MARUCCI ENGINEERING ASSOCIATES, LLC

January 21, 2025

Re: 211 East Passaic Avenue
Map 28 Block 752 Lot 82
Frank Grossi (owner/applicant)
Zone: R-2B, Two Family Residential District

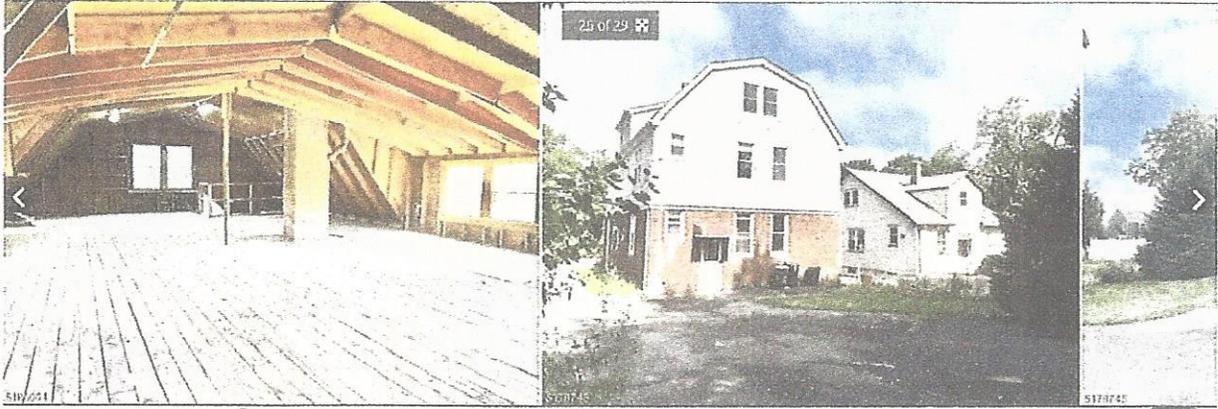
Attachment #2 is a photograph of the interior of the attic prior to the renovations.
The attic was completely unfinished prior to the improvements made without permits.

The third floor attic kitchen, bathroom and laundry room shall be removed in their entirety.
